## SUBDIVISION REVIEW SHEET

**CASE NO.:** C8-2020-0501

**SUBDIVISION NAME:** Mountain Crest Preliminary Plan

CITY OF AUSTIN –DEVELOPMENT SERVICES DEPARTMENT  
SUBDIVISION APPLICATION – MASTER COMMENT REPORT

PP01

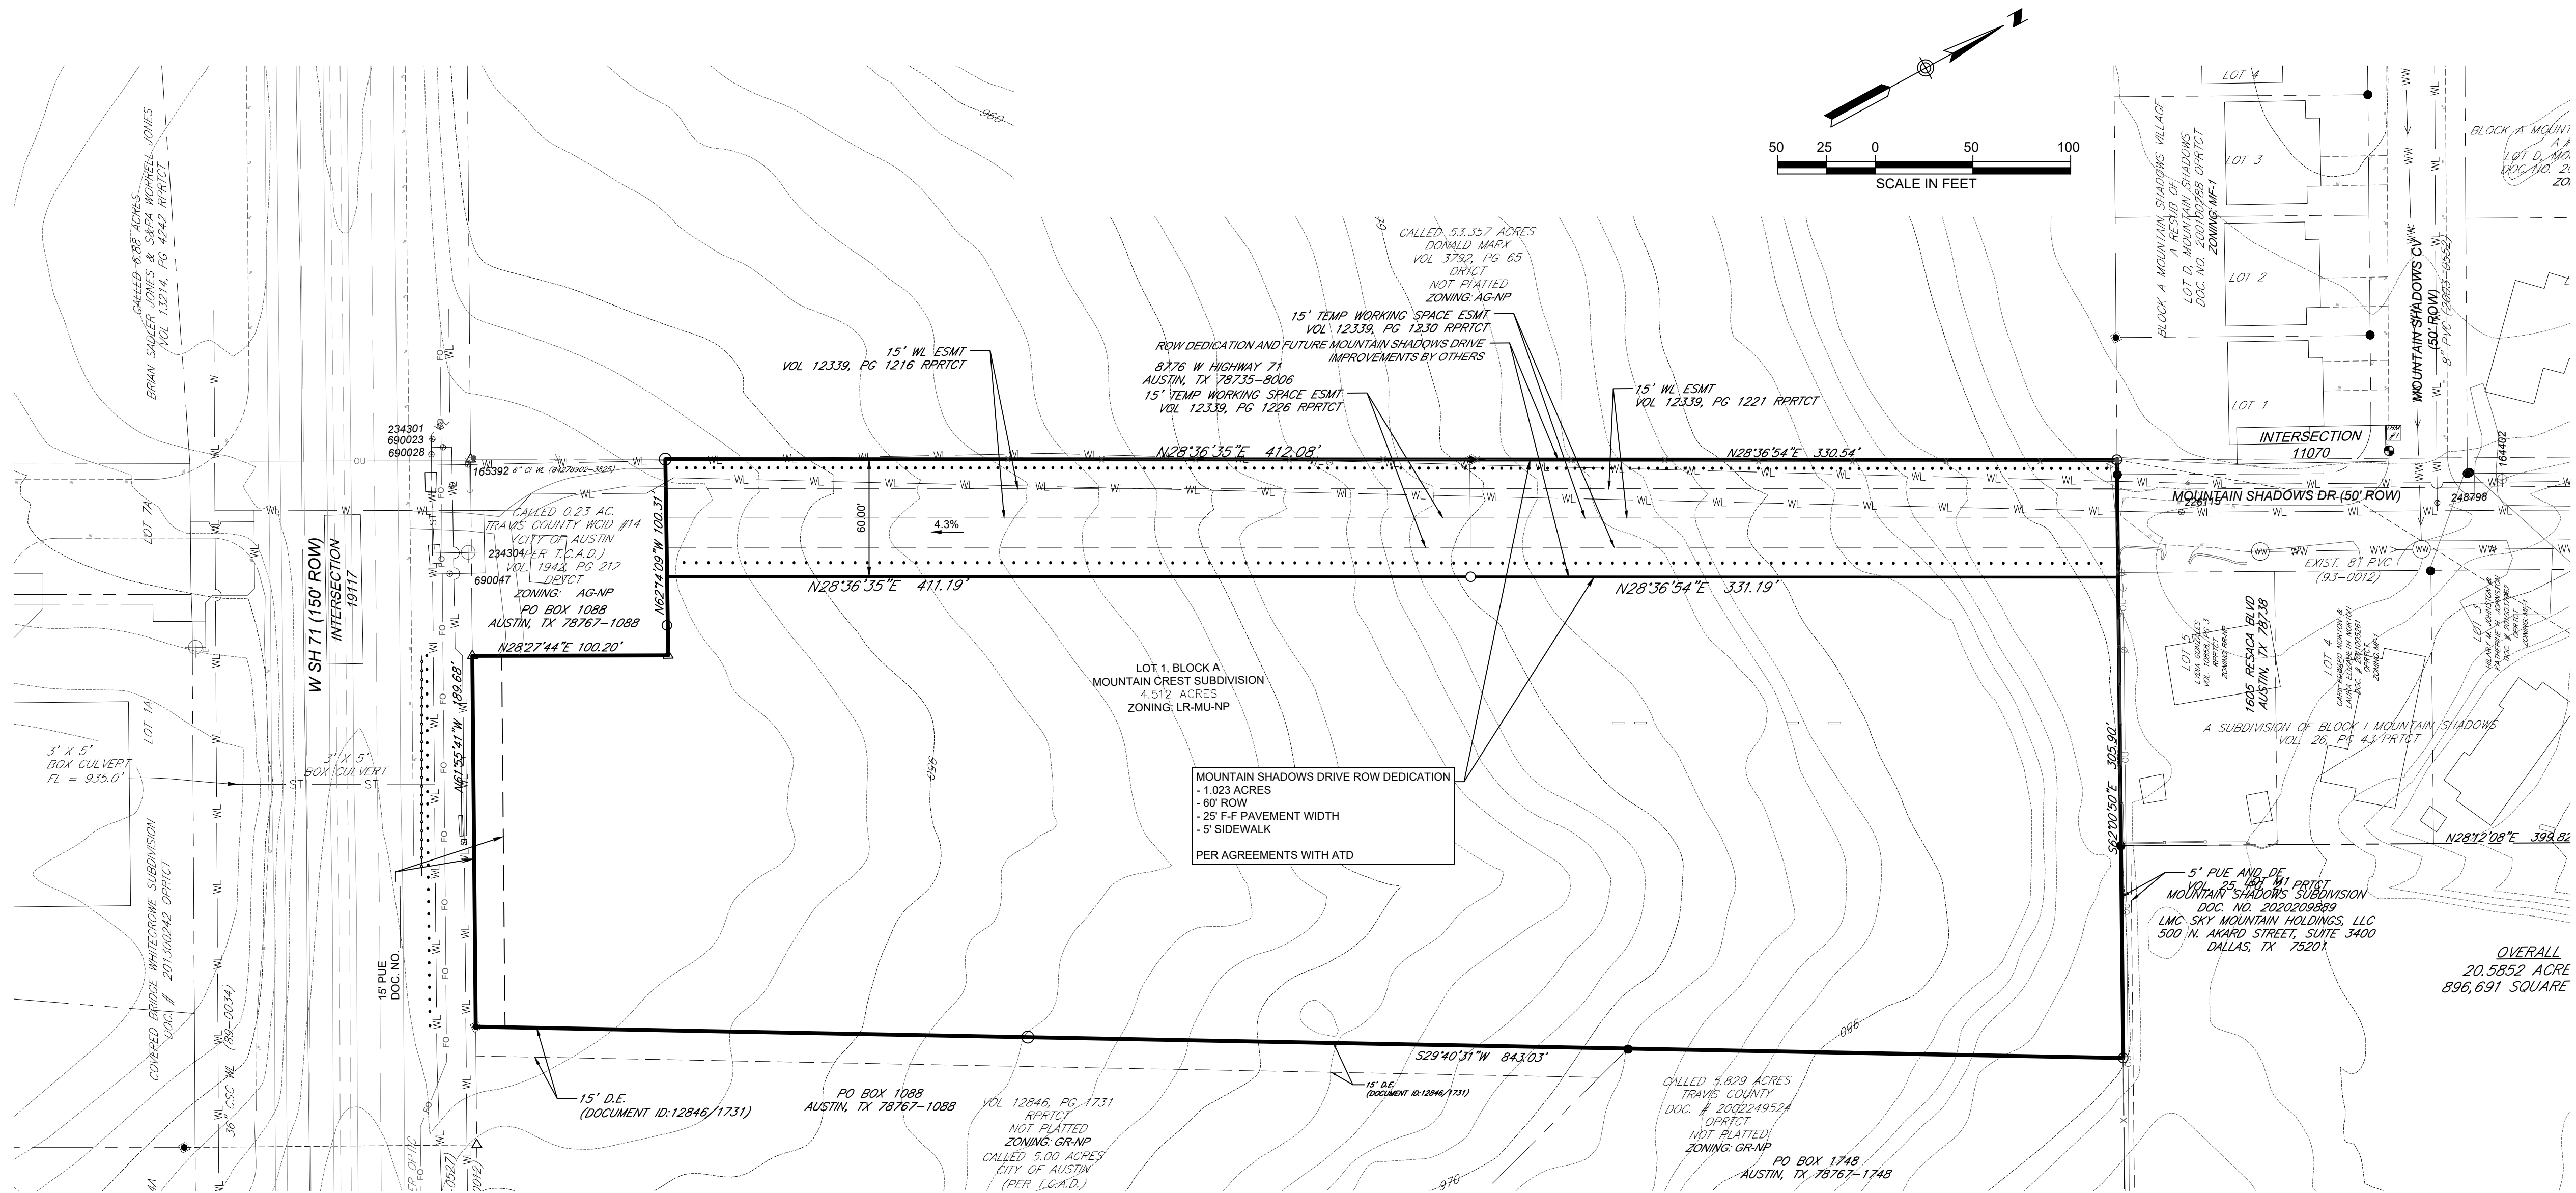
ATD1. Remove Note 13 from the preliminary plan; it is not an accurate statement and an inappropriate condition to memorialize on a preliminary plan. LDC 25-6-171(a)

SR 1. In the approval block on all sheets, update the following information:

- Application date to November 22, 2021.
- Following Under Section, list 25-4-57.
- List Cesar Zavala before Denise Lucas' information.

SR 2. Add the lot square footage inside the lot by the 4.512 acreage information.

Pursuant to compliance with Sections 307.1, 609.6, and 721.1 of the 2021 Uniform Plumbing Code, add a plat note that conveys the following: **This single lot subdivision shall have independent sewer tap(s), independent water meter(s), and its private water and sewer service lines shall be positioned or located in a manner that will not cross lot lines.**
